MFN 03-099
September 16, 2003

Subject: **Response to Request for Additional Information (RAI) numbers (70, 71, 82, 86, 87, 316, and 318) for ESBWR Pre-application Review.**

Response to NRC RAI numbers (70, 71, 82, 86, 87, and 316), and additional information provided in response to RAI 318

Figure 316-1. Comparison of correlations for Liquid Side Interfacial Heat Transfer for Bubbly Flow.

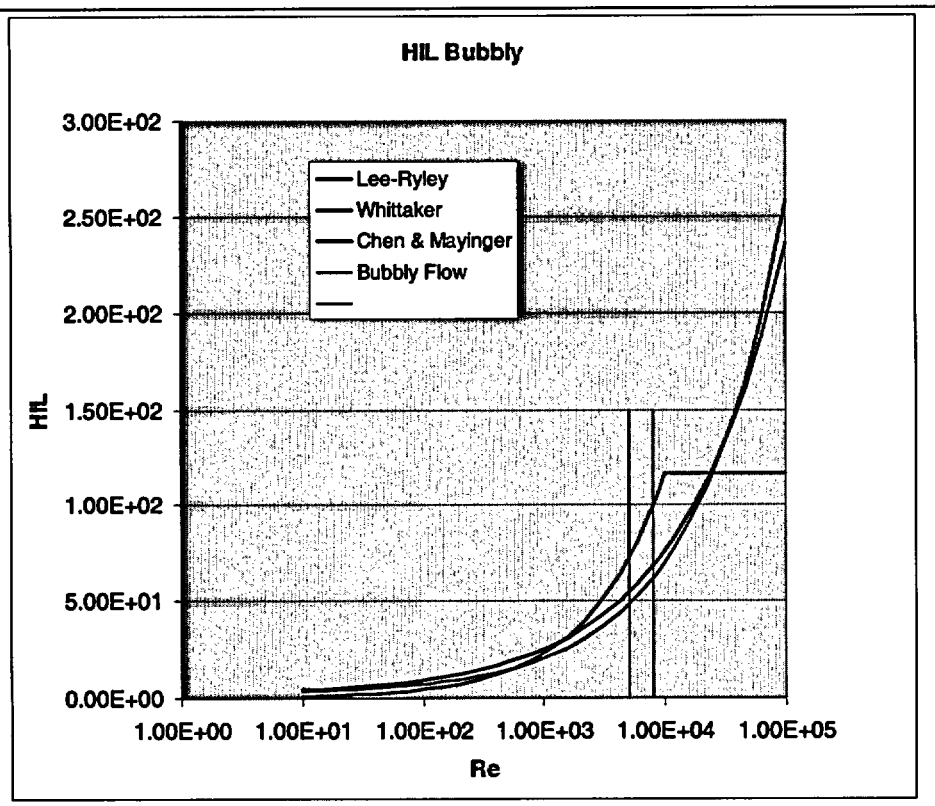
Q316.1. It is our understanding that the liquid side interfacial heat transfer coefficient is obtained from a correlation developed for heat transfer over evaporating drops. Provide a description of the physical process being modeled and justify its use for this situation.

These correlation are compared in Figure 316-1 for Pr = 1.0.

For bubbly flow the Reynolds number for the bubbles are typically in the range of 5000 to 8000. For this range the Whittaker correlation is 10% lower than the Lee-Ryley correlation, and the Chen & Mayinger correlation is approximately 40% higher than the Lee-Ryley correlation. These differences are compatible with the uncertainty range for the correlations.

The good comparison to void fraction data and plant transient data as demonstrated in the TRACG Qualification (NEDE-32177P) justifies the application of the Lee-Ryley for the interfacial heat transfer. In the TRACG application (NEDE-32178P) a factor of 2 (-50%, +100%) uncertainty is assumed for liquid side interfacial heat transfer. This uncertainty more than covers the difference between the above correlations.
